HISTORIC AND DESIGN REVIEW COMMISSION

August 2, 2023

HDRC CASE NO: 2023-286
ADDRESS: 2030 W MULBERRY AVE
LEGAL DESCRIPTION: NCB 1952 BLK 20 LOT 21
ZONING: R-6, H
CITY COUNCIL DIST.: 7
DISTRICT: Monticello Park Historic District
APPLICANT: Jerry Woolf | J.B. Woolf Sheds
OWNER: Robert Chalk
TYPE OF WORK: Construction of a garage structure
APPLICATION RECEIVED: July 7, 2023
60-DAY REVIEW: September 5, 2023
CASE MANAGER: Bryan Morales

The applicant is requesting a Certificate of Appropriateness for approval to construct a detached, split-bay garage on a slab foundation at the rear of the property.

Proposed 24x24 Garage on SLAB

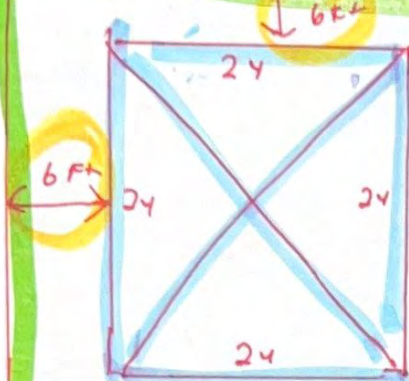
- c. **ORIENTATION & SETBACKS** – The applicant has proposed both an orientation and setback for the new accessory structure that are consistent with the Guidelines for New Construction 5.B.

- i. That the applicant install a fiber cement board that features a reveal no more than 6 inches and a smooth finish.
- ii. That the applicant install a garage door that uses wood as the primary material or have the appearance of wood.
- iii. That the applicant abide by all setback requirements.

ELEVATIONS

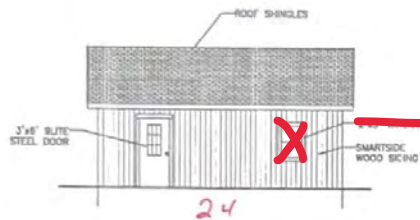
- d. **ARCHITECTURAL DETAILS (MATERIALS)** – The Guidelines for New Construction 5.A.iii. and iv. note that new accessory structures should relate to the period of construction of the primary historic structure on the lot by using complementary materials and simplified architectural details. Staff finds the proposed composition shingle roof conforms to the guidelines. Staff finds the installation of the Smartside wood siding does not conform to guidelines. Guideline 2.B.i states that roof forms—pitch, overhangs, and orientation—consistent with those predominately found on the block should be incorporated. Staff finds the proposed gable roof on the accessory structure conform to guidelines.

- e. **ARCHITECTURAL DETAILS (FENESTRATION PATTERN)** – The applicant is proposing to install a split-bay garage door on the front-facing elevation and a door on the side elevation. The Guidelines for New Construction 2.C.i. related to window and door openings stipulates to incorporate window and door openings with a similar proportion of wall to window space as typical with nearby historic facades. Staff finds the proposed fenestration pattern generally conforms to guidelines.
